Planning App Ref:	PL/2026/01815
Service Ref:	Drainage
Date:	21/04/2026

Full planning permission for proposed new dwelling & landscaping.

Land adjoining 79 Dickens Avenue, Corsham, SN13 0AQ

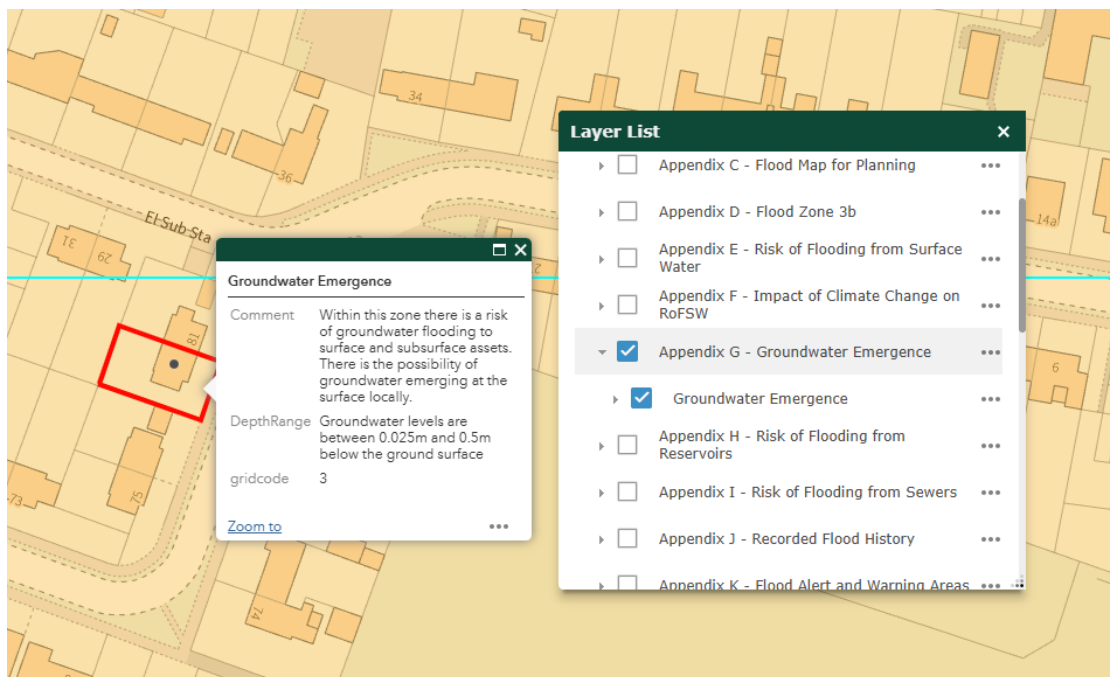
The site has a low level of risk from surface water flooding, although the road along the front of the site falls within the 1 in 1000-year flood extent.
